PILOT BOARDING DEFICIENCY REPORT

VESSEL: MOL GLIDE

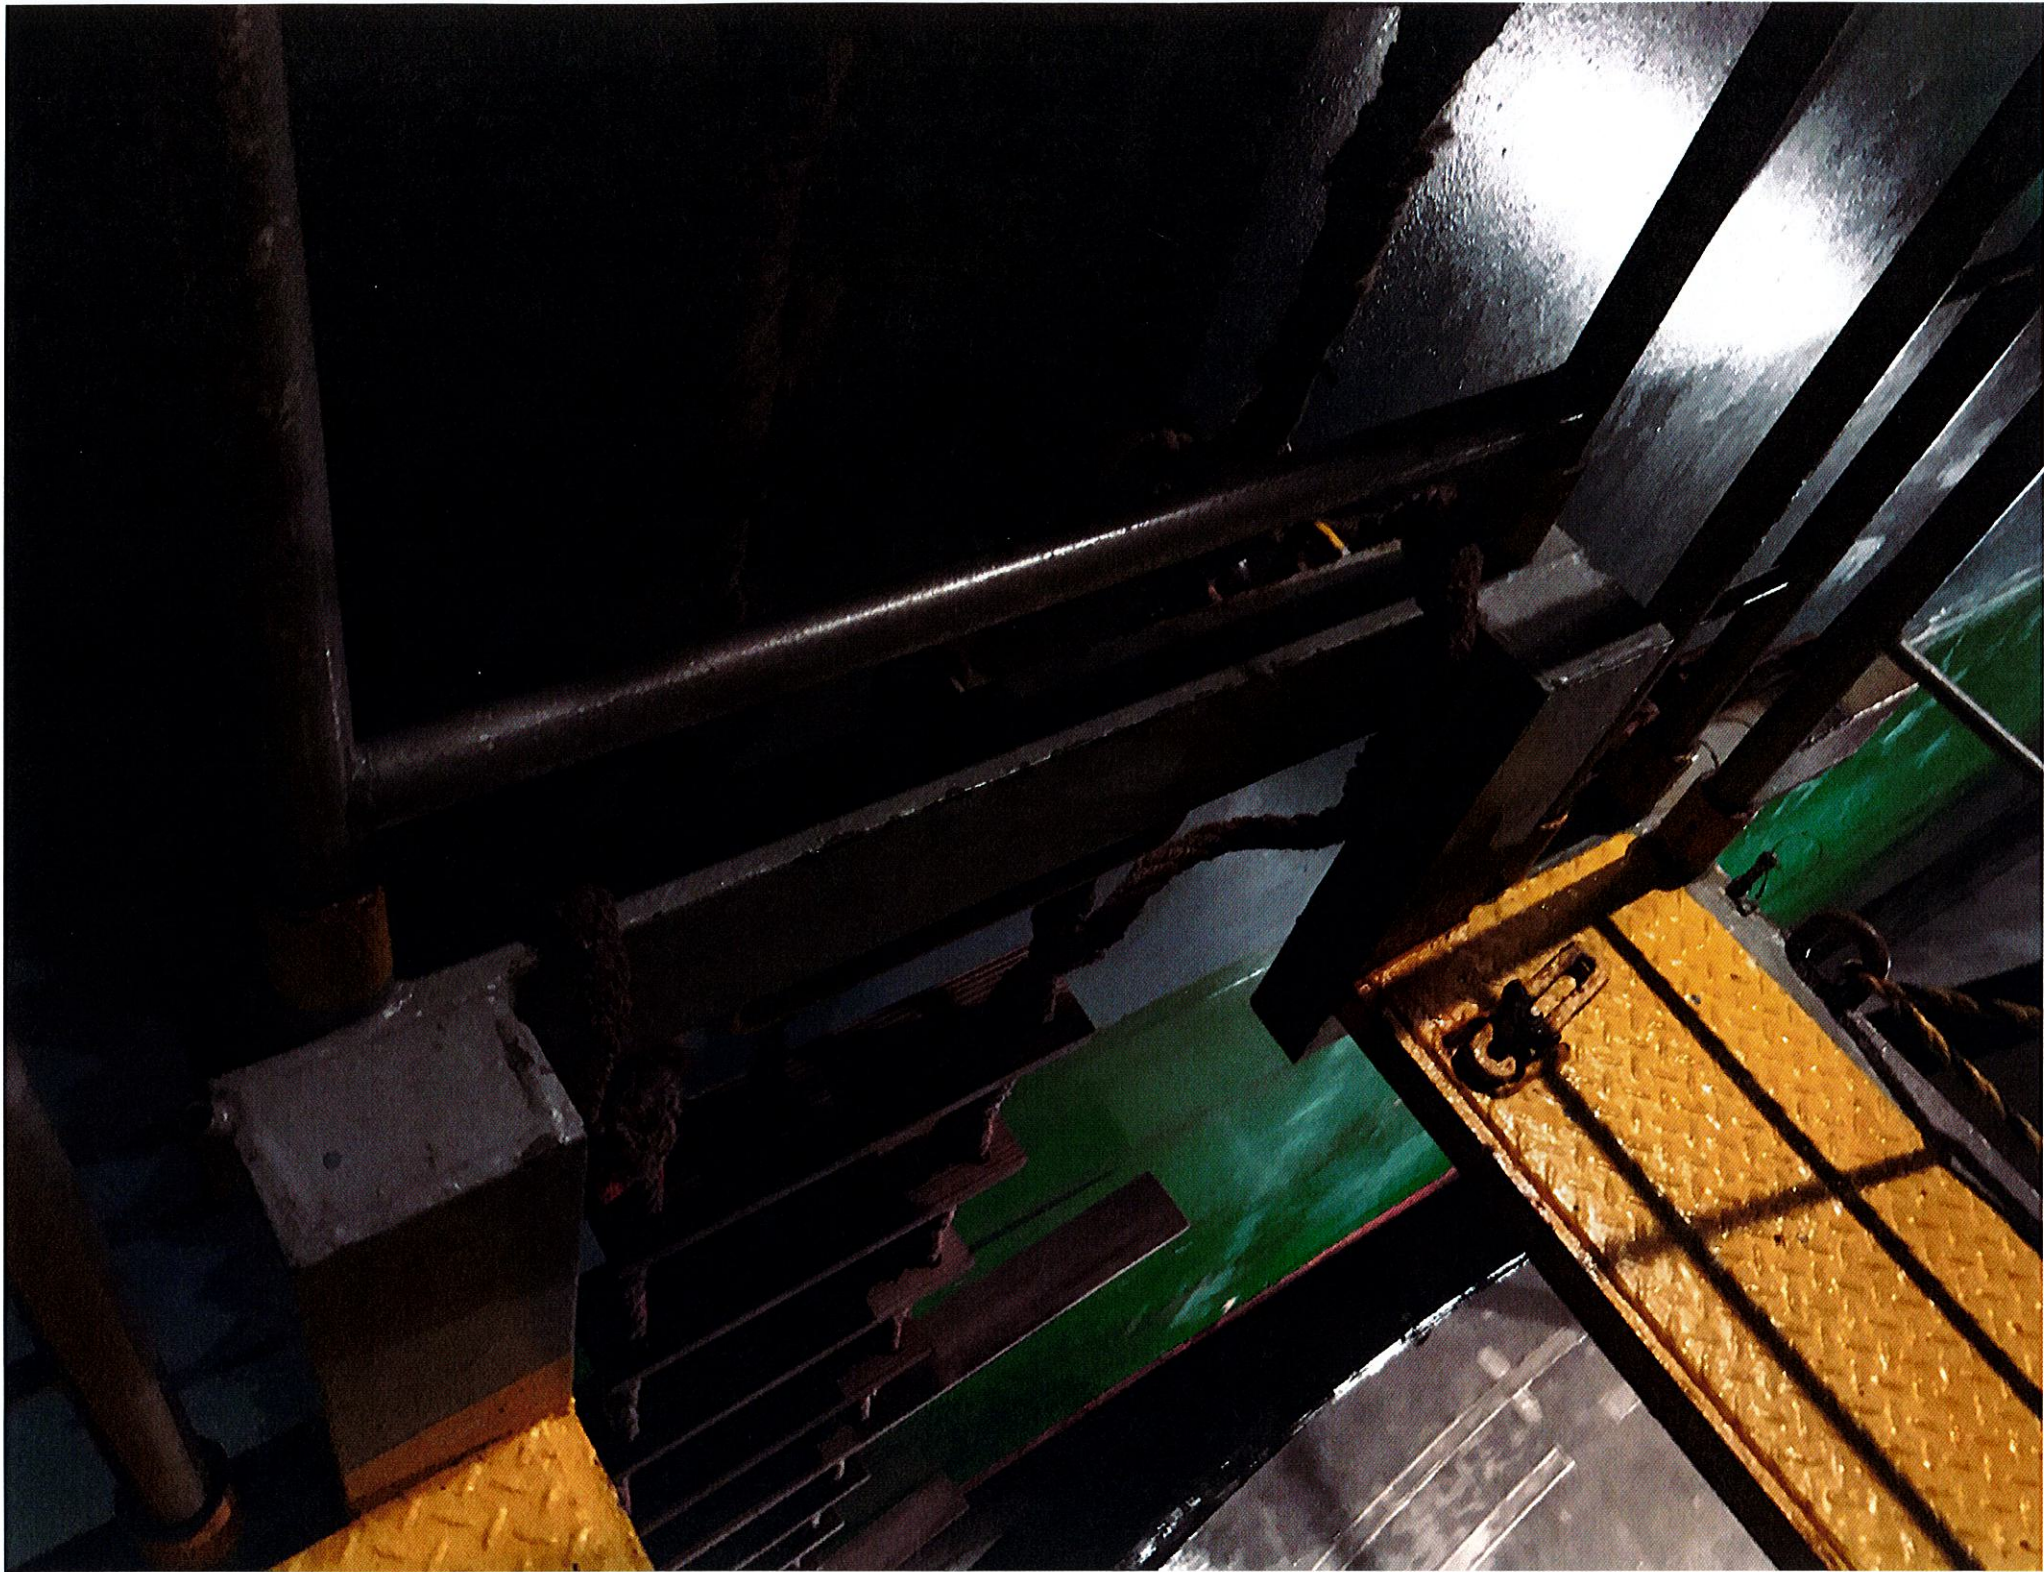
☒ COMBINATION LADDER (ie: Poor condition/wear, not secured, platform too low, etc.)

TRAP DOOR WITH CROSS BAR in the way

ADDITIONAL REMARKS: Capt and OWNERS AWARE TRAP DOOR needs to be corrected. Capt
gave pilot copy of plans for modifications APPROVED BY
ABS (CLASSIFICATION society) Capt stated he hopes OWNERS WILL

HAVE MODIFICATIONS MADE IN A FEW MONTHS.

<STORAGE & HORIZONTAL CONDITION>

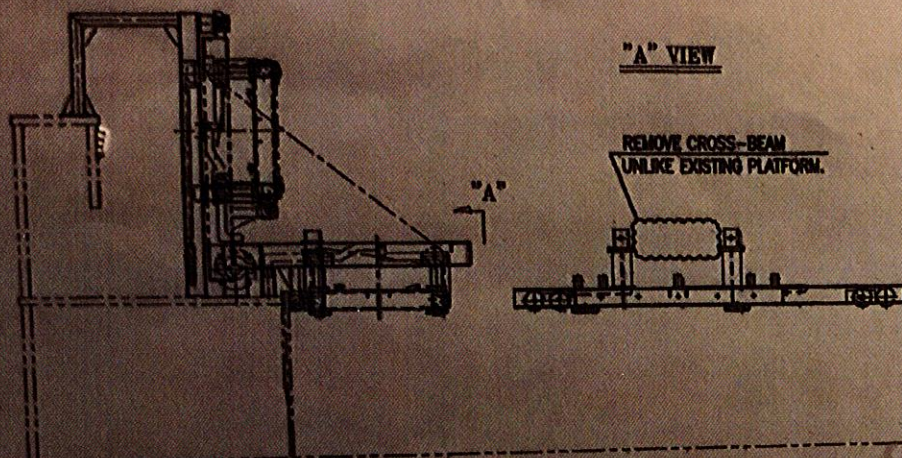
REMOVE CROSS-BEAM
UNLIKE EXISTING PLATFORM.

<HANDRAIL ASSEMBLY CONDITION>

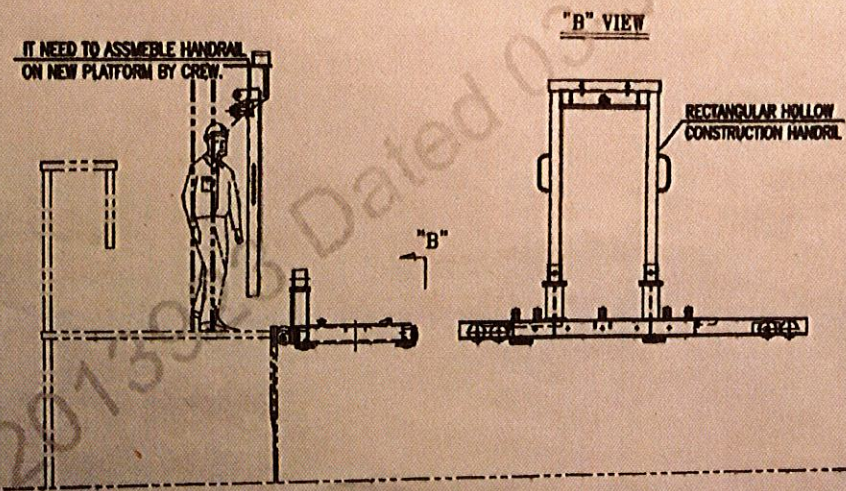
IT NEED TO ASSEMBLE HANDRAIL
ON NEW PLATFORM BY CROFT

RECTANGULAR HOLLOW
CONSTRUCTION HANDRAIL

<PILOT EMBARKATION CONDITION>

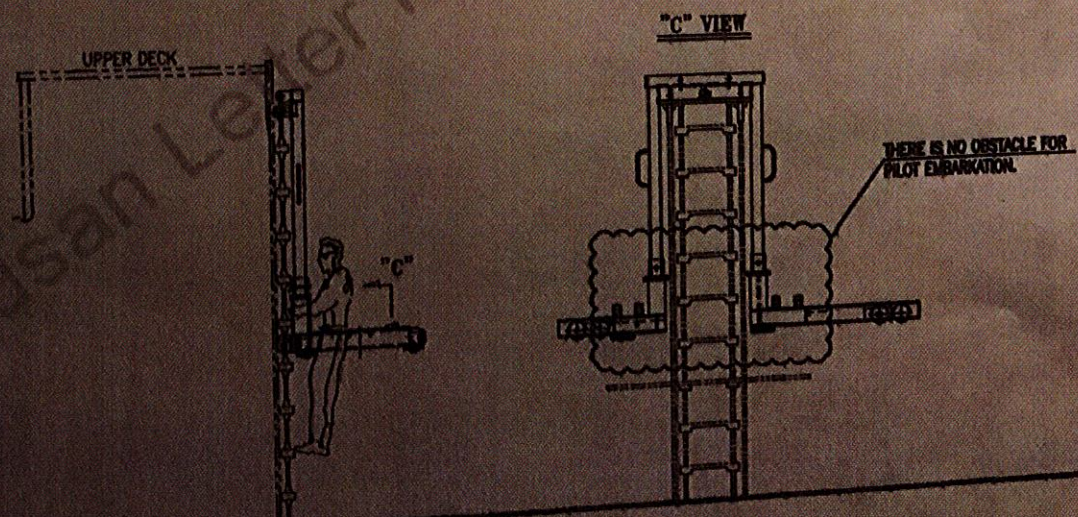
THERE IS NO OBSTACLE FOR
PILOT EMBARKATION.
